Economic Commission for Europe**Inland Transport Committee****World Forum for Harmonization of Vehicle Regulations****Working Party on Brakes and Running Gear****Eighty-first session**

**International Whole Vehicle Type Approval (IWVTA) –
Regulation No. 13-H****Proposal for amendments to Regulation No. 13-H (Braking of
passenger cars)****Submitted by the experts from the International Organization of Motor
Vehicle Manufacturers ***

This document supersedes document ECE/TRANS/WP.29/GRRF/2014/10 and is based on informal documents GRRF-79-05-Rev.1 and GRRF-80-32. The changes to the current text of the regulation are marked in bold for new and strikethrough for deleted characters.

Annex 2,

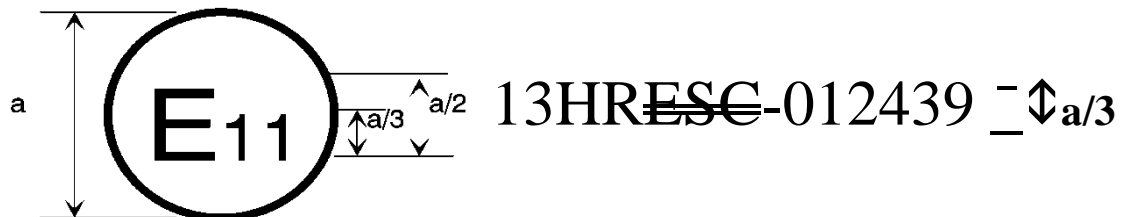
Approval mark and Paragraph of Model A, amend to read:

" The above approval mark affixed to a vehicle shows that the vehicle type concerned has, with regard to braking, been approved in the United Kingdom (E11) pursuant to Regulation No. 13-H under approval number 012439. The first two digits of the approval number indicate that the approval was granted in accordance with the requirements of Regulation No. 13-H in its ~~original form~~ **01 series of amendments**. The additional marking "ESC" indicates that ~~the vehicle meets the Electronic Stability Control and Brake Assist System requirements of Annex 9 to this Regulation.~~ "
